ADDENDUM #3

Reference: Camp Williams

144th Medical Company Readiness Center

DFCM # 04043480

SHEET E702: Intrusion Detection System Riser:

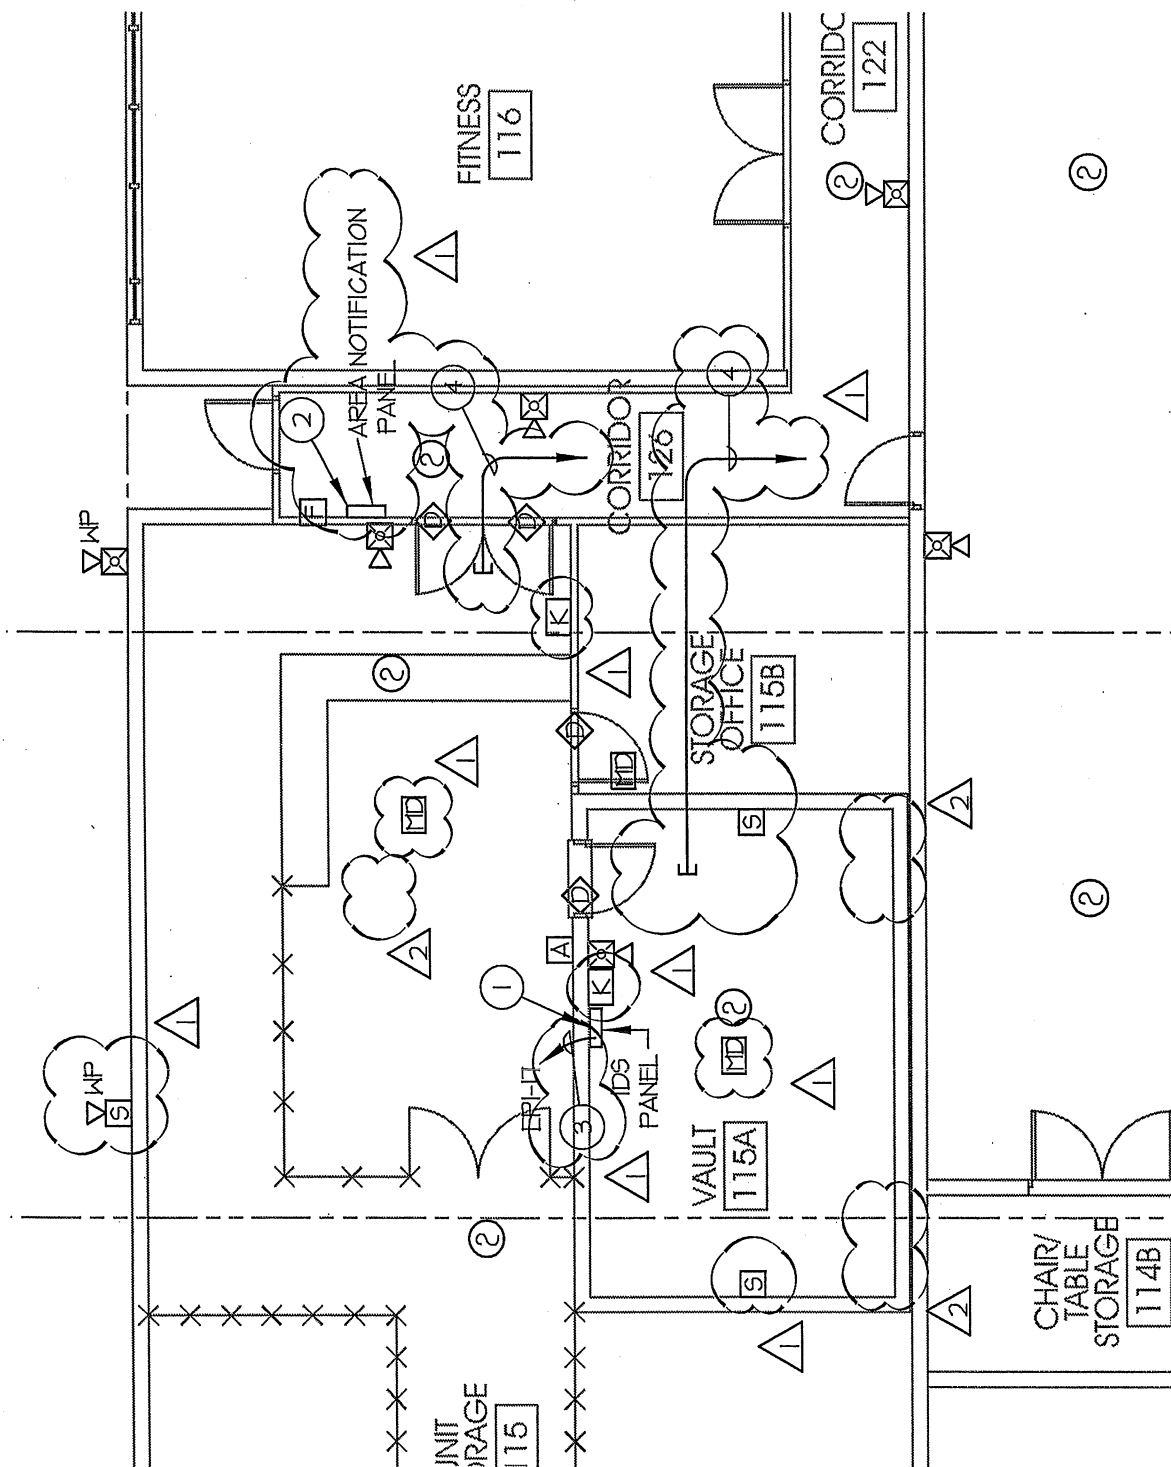
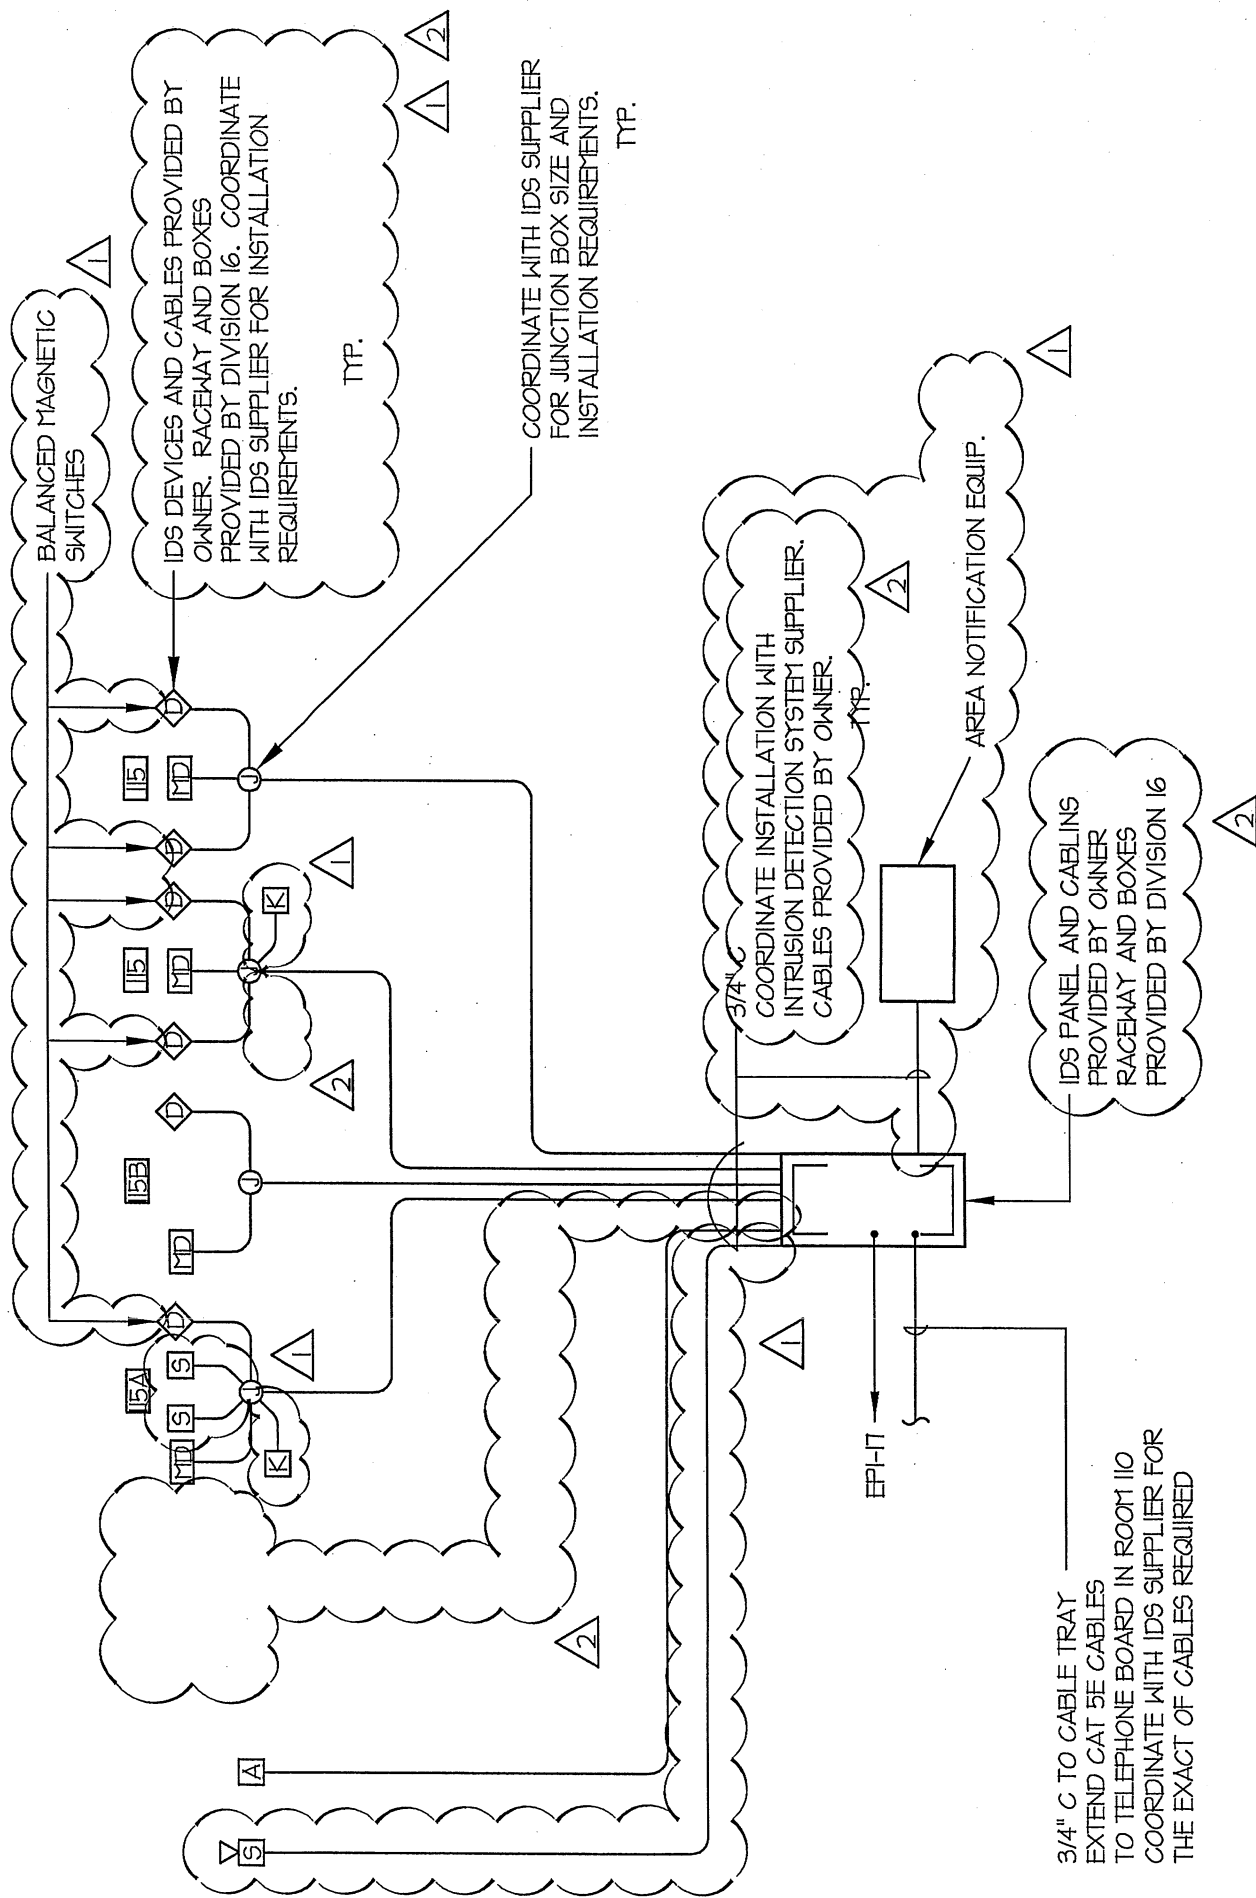
1. Change several devices for IDS system in Unit Storage 115, Vault 115A and Corridor 128 areas for compliance to owner requirements.

1. Several devices have changed to reflect changes made to Sheet E501 above.

AD2.1

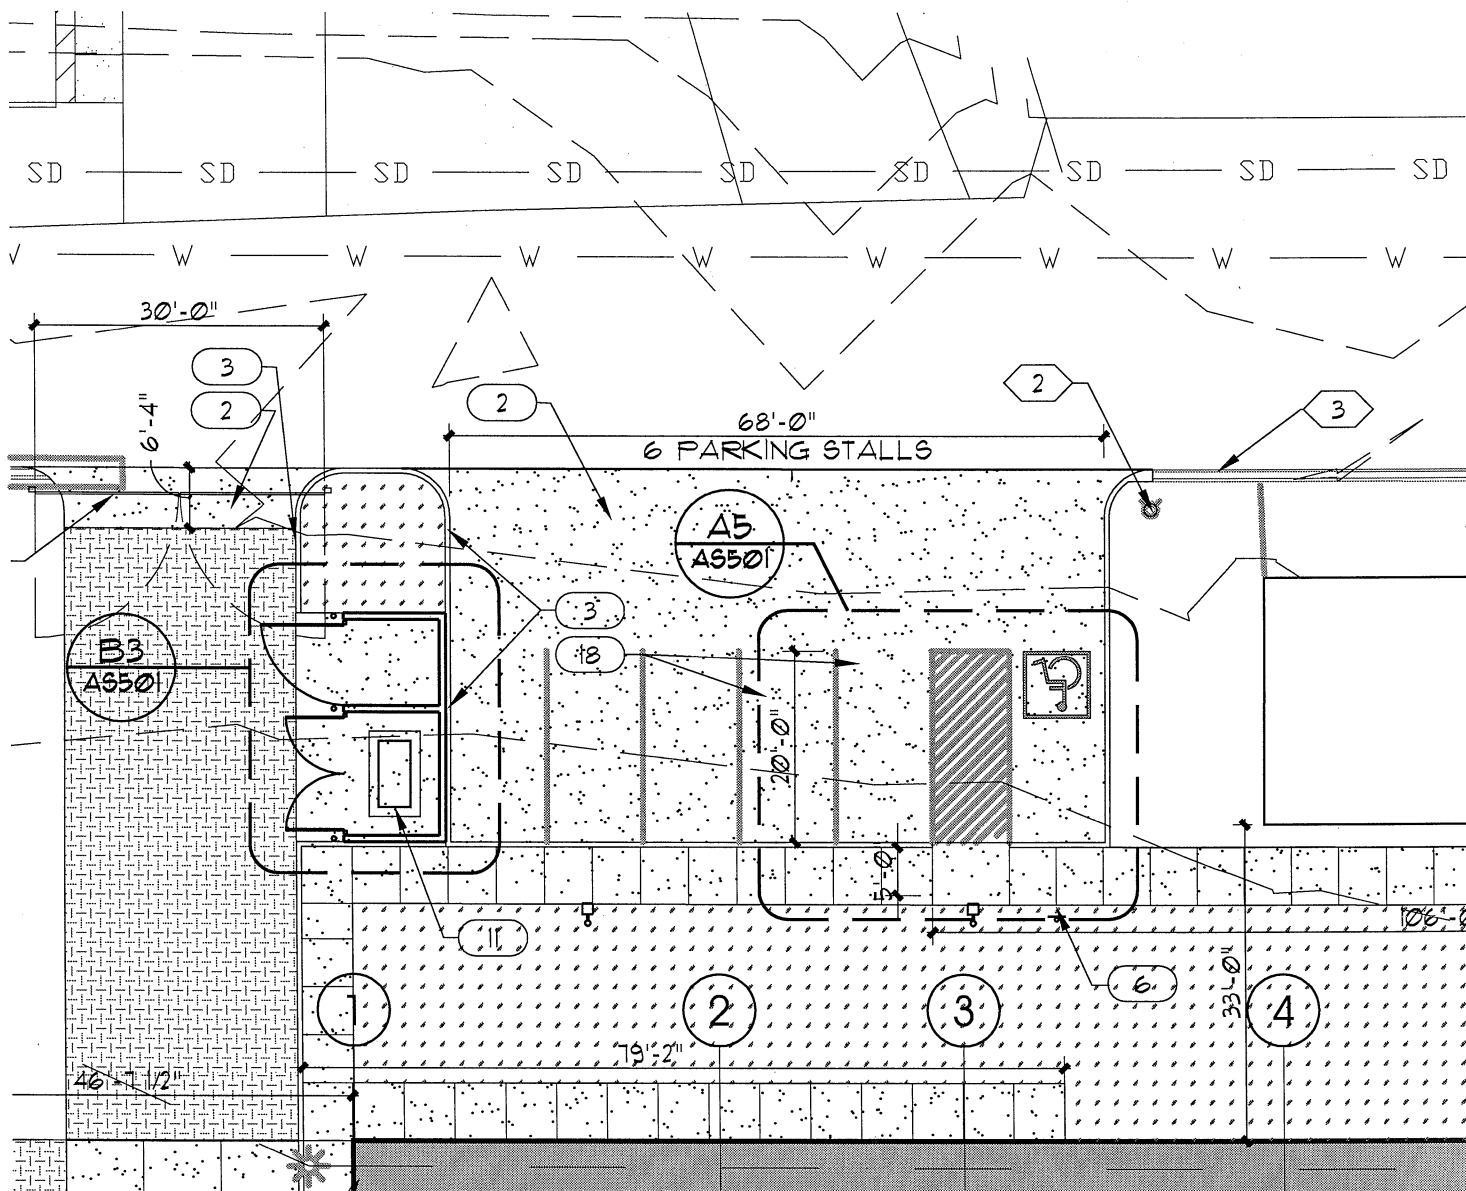
Item 15: Include (2) parking stalls dedicated to carpool only as indicated on attached supplemental drawings AD2.1.

18 CARPOOL ONLY STALL - GC TO PROVIDE SIGNAGE (NOTE DETAILS SIMILAR TO C4/A6501 AND C5/A6501).
